RE: City of Emmonak Washeteria

TRIP REPORT
VILLAGE SAFE WATER

PURPOSE: Inspect New Washeteria

Subject: Post-Construction Performance Evaluation
New Washeteria Building
Emmonak, Alaska
DM&A Job No. 4135.006

Figure 3. Perimeter cross bracing and loose debris around the pile supports at the southwest building corner.

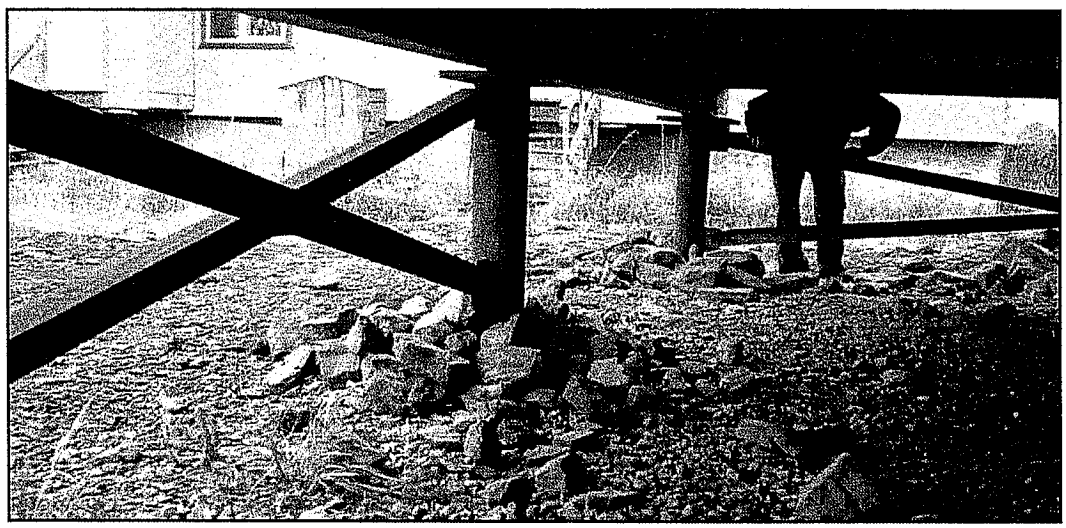
Above grade cross-bracing was added during construction to some perimeter and interior pile supports to increase the lateral stiffness of the foundation against wind and seismic loads and to control vibratory loads from the laundry equipment. Perimeter cross-bracing consisted of 3-inch angle steel. Interior bracing consisted of 4-inch pipe. Large cobbles and small boulders were observed around many of the perimeter piles as shown in Figure 3. In addition to the cobbles and boulders, several piles were partially buried by the edge of the parking area fill pad. Based on the observed surface wear at the interior piles, the near surface soils experience approximately 6 inches of seasonal frost heave annually.

- Manually remove the loose cobbles and boulders from around all piles and cross bracing along the south side of the building so that future ground motion will not cause interference with the above grade support structure. Provide at least 6 inches of clearance under the cross bracing.

Figure 4. Typical appearance of damaged cross bracing (southwest corner).

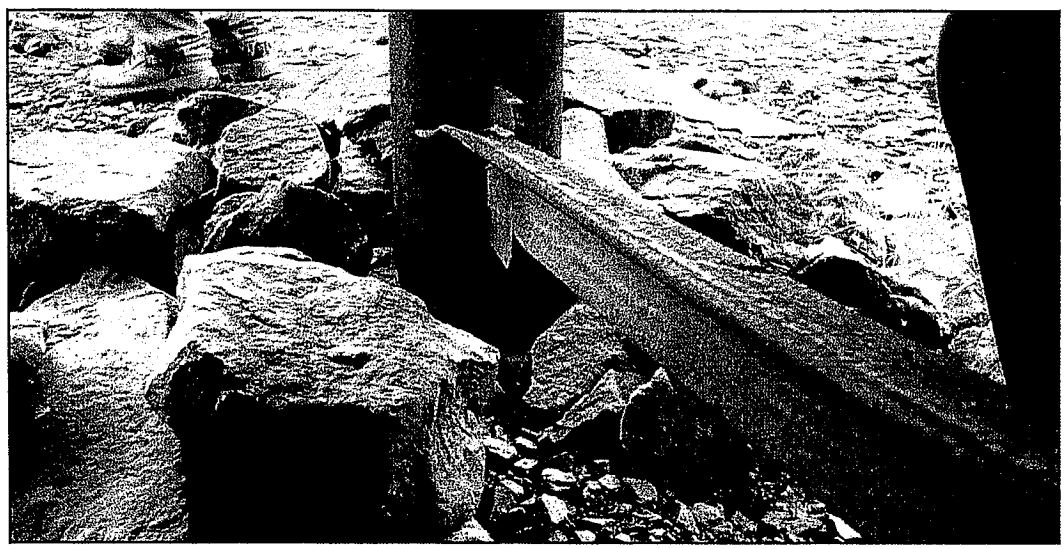
The bottom edges of the cross bracing appeared damaged at several locations along the perimeter. At the time of our visit, loose rocks were observed beneath the cross bracing at each of these locations. We expect the rocks engaged the bracing in these areas in the past as the surficial soils heaved due to seasonal frost action. Figure 4 shows an example of the cross bracing damage typically observed. The locations where damaged bracing was observed are at areas where up to 1-inch of uplift was measured.

Figure 5. Separated plywood at arctic pipe penetrations into utility enclosure (SE corner).

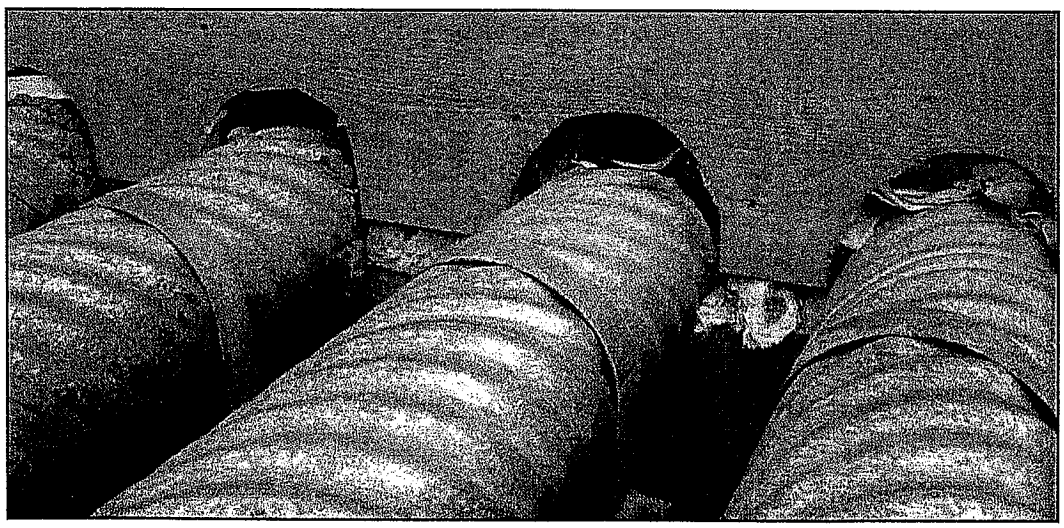
Water and sewer service is provided by above ground insulated pipes which enter the washeteria through a plywood utility enclosure under the southeast corner of the building. We observed evidence of approximately 2 to 3 inches of previous displacement where the pipes pass into the enclosure (Figure 5). The enclosure is accessed from the interior of the building and contains the water supply and wastewater manifolds. We assume the enclosure is insulated. We do not know if the pipes have a flexible connection where they enter the building. Most of the walls of the enclosure were in contact with the ground beneath the building at the time of our visit. This type of enclosure is typically suspended from the floor beams or joists and designed to provide enough clearance between the bottom of the enclosure and the ground surface to avoid interference caused by seasonal ground motion associated with frost heave.

We also noted the water and sewer pipes were supported by treated timber cribbing immediately adjacent to the building. The timber cribbing rests on the ground surface and is subject to seasonal ground motion. If the pipes do not have a flexible connection where they enter the building, any uplift of the timber cribbing could result in uplift of the building.

- Lower the existing grade below the utility enclosure by manually excavating material so that at least 6 inches of clearance is provided below the enclosure at all points. Care should be taken to maintain positive drainage so that surface water runoff does not collect underneath the enclosure or around nearby piles.

- Provide an allowance for seasonal movement of the water and sewer pipes. This may be accomplished either by locating the supporting timber cribbing further from the enclosure or designing flexibility into the pipe penetrations and connections inside the enclosure.

Figure 6. Revised cross section for parking area fill pad embankment.

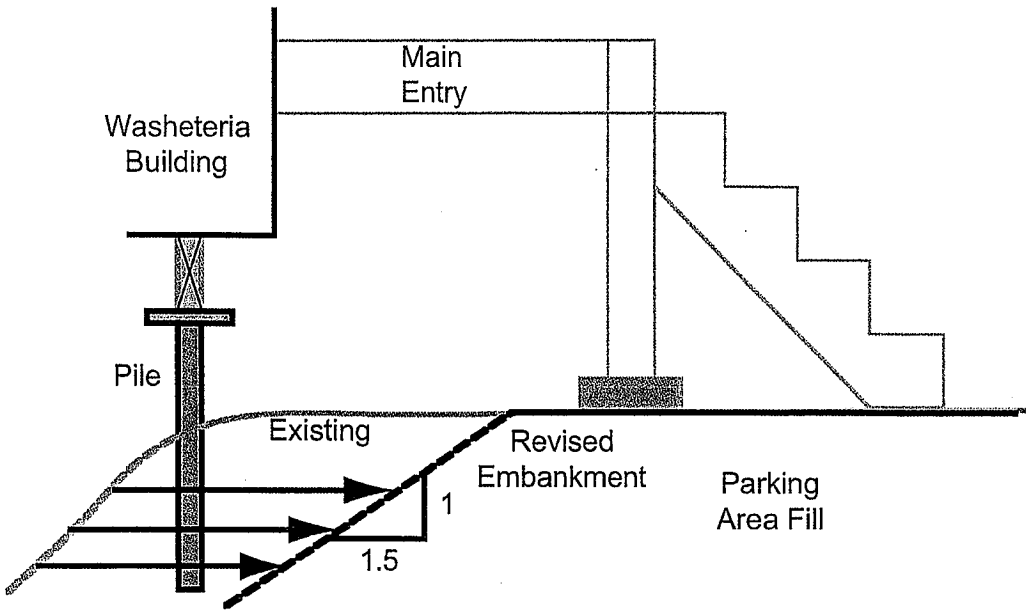
Access from Emmonak Road and customer parking is provided by a granular fill pad north of the washeteria. The fill limits extend to the building eaves along the north side of the building and approximately half way along the east and west sides. The toe of the fill embankment in these areas extends underneath the building and around the pile supports as shown in Figure 2. In some areas, large cobbles and small boulders are in contact with the diagonal bracing. The total thickness of the fill ranges from 1.5 to 3 feet along the building eaves.

- Remove the parking area fill and loose rocks from around the pile supports and cross bracing along the north, east, and west sides of the building. Reestablish the fill pad such that the toe of the embankment does not extend to the piles under the building. The embankment shoulders should be sloped at 1.5 horizontal to 1 vertical (1.5:1) or flatter.

SITE LAYOUT and PHOTO KEY
New Washeteria Building
Emmonak, Alaska

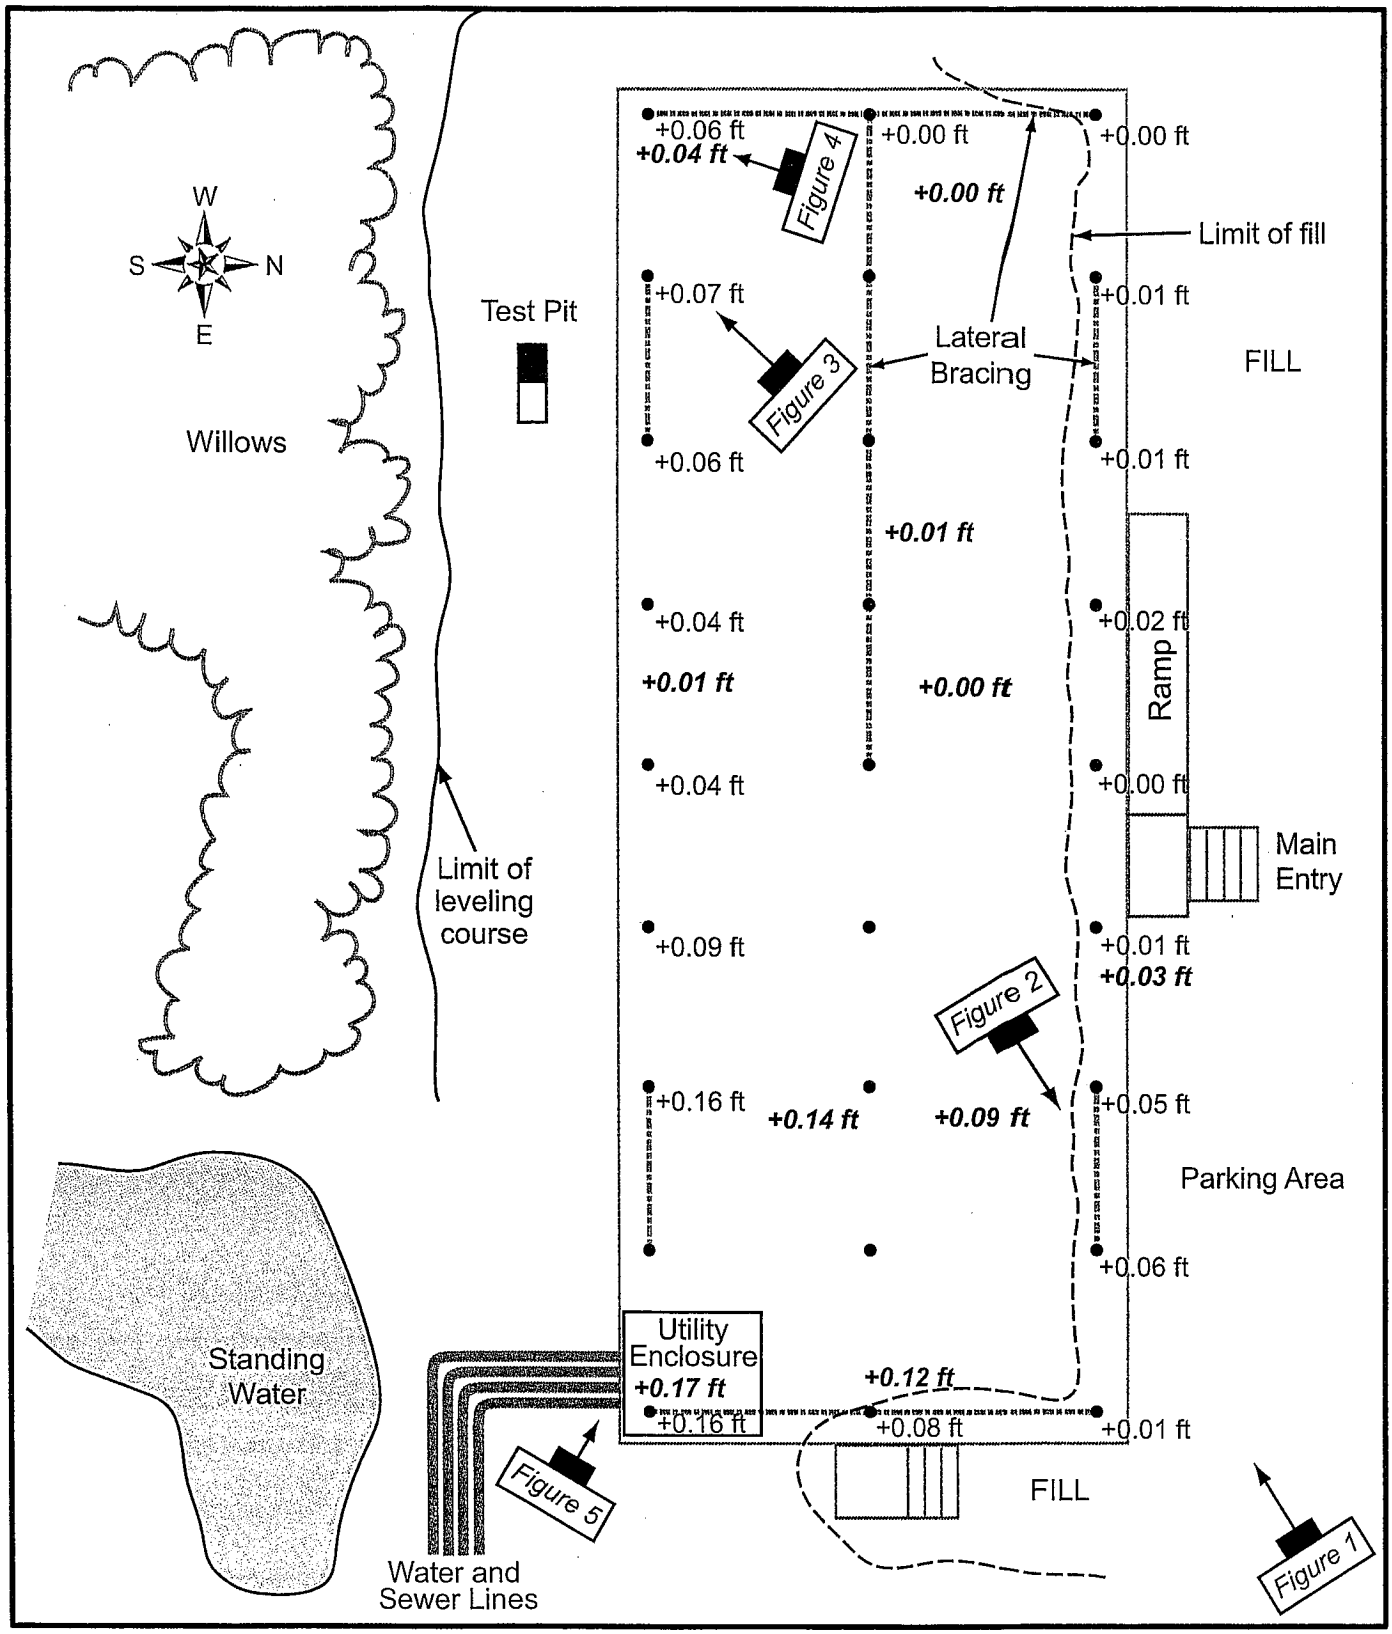
We measured relative levels of the bottom of the glulam beams around the perimeter of the building using an auto-leveling laser and detector. Relative

interior finish floor heights were also measured for comparison. Both surveys indicate the southeast corner of the building is approximately 2 inches higher than the rest of the building areas. The survey results are shown on Plate 1.

The survey results show differential vertical movement has occurred. We expect the relative displacements are attributable to upward movement of piles subjected to localized frost heave forces. The alternate scenario of downward movement associated with pile settlement in the areas of the building where lower floor elevations were measured is unlikely.
